Re: Structural Design and Construction Report – Zone A

Project: Greystanes Public School (PS)

SITE VISIT REPORT / SITE INSTRUCTION

Inspection: OSD Wall Reinforcements Report No: N020031 - spt-2020.08.04

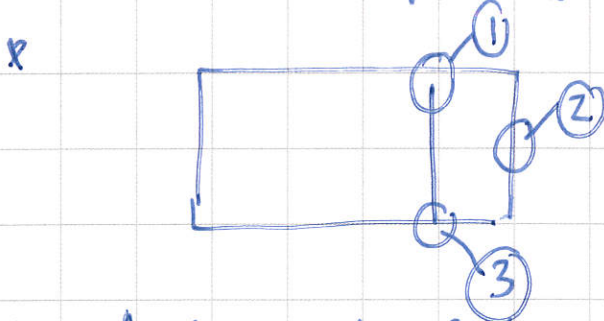
- 1) At 'T' Junctions of Drilled wall, install vertical bars w/'U' horizontal bars @ 300 centres

- 2) Add vertical bar & 'L' Bar N16 at this location
- 3) 'U' Bar @ top need to extend all the way to long wall elevation.

GROUND FLOOR PLAN - ZONE A

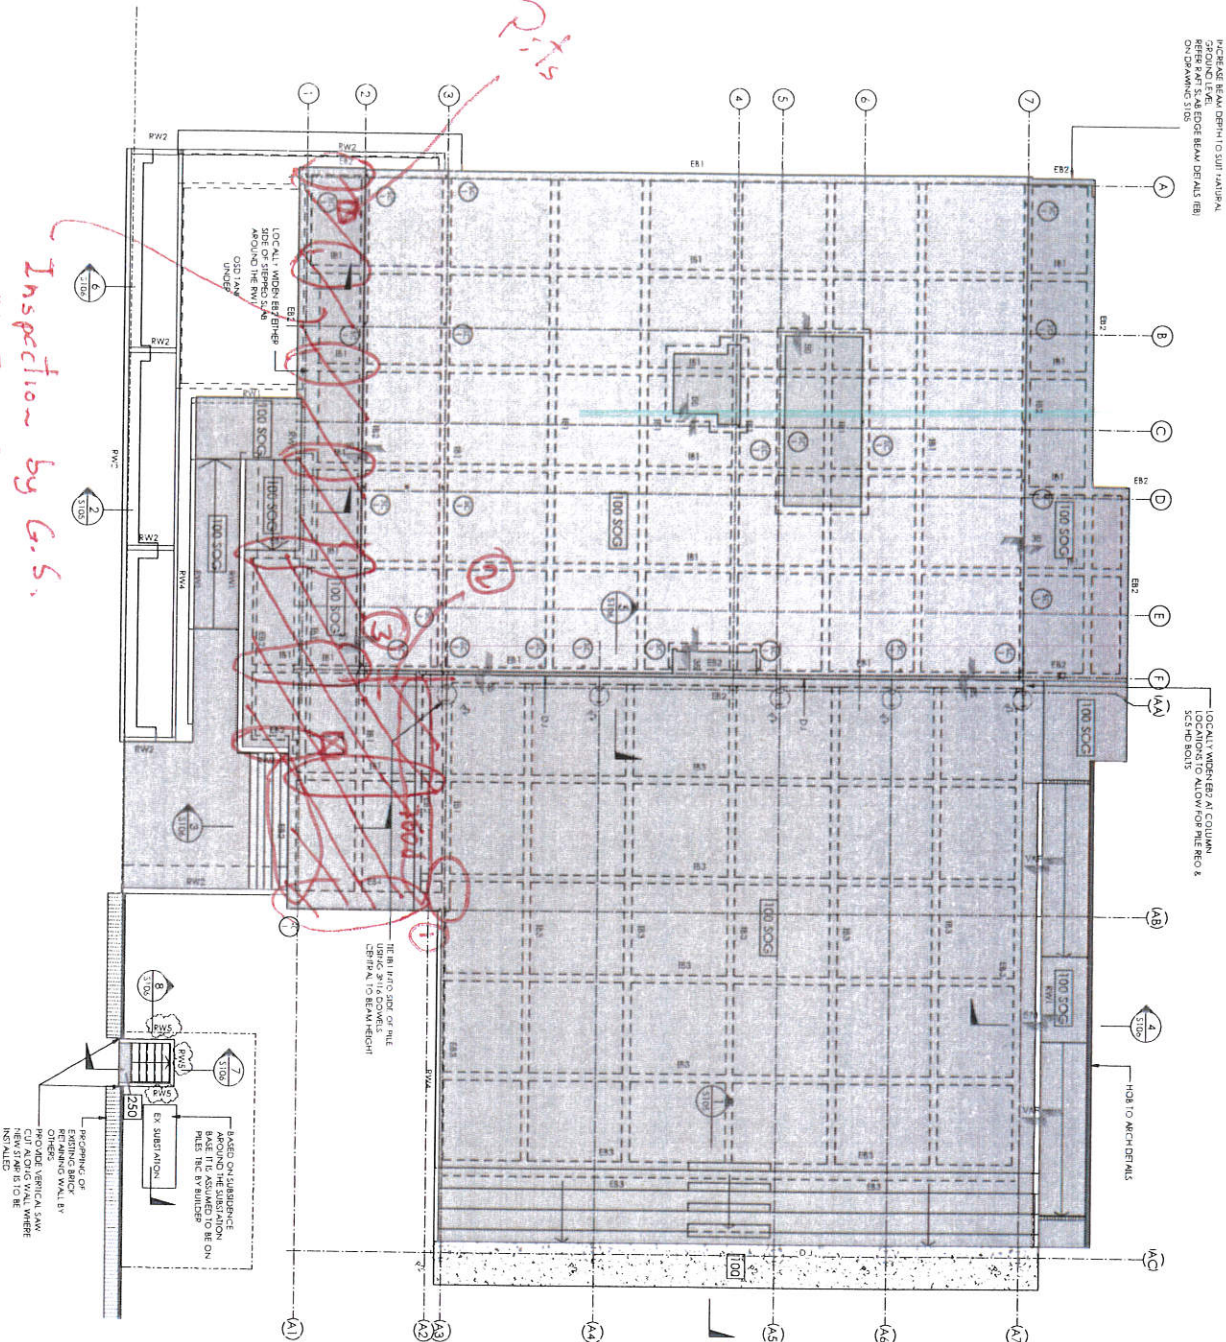
Refer to attached site mark up drawing

1. Continue mesh and N12 bars to provide sufficient lap for next stage of concrete
2. Add 2N12 edge bars between dowels full length of edge
3. Add 1 missing dowel.

INCREASE BEAM DEPTH TO SUIT NATURAL
GROUND LEVEL
REFER RAFT SLAB EDGE BEAM DETAILS (REB-
ON DRAWING S105)

- 1 Add mesh for lap to future
- 2 2012 edge bar
- 3 1 down! missing
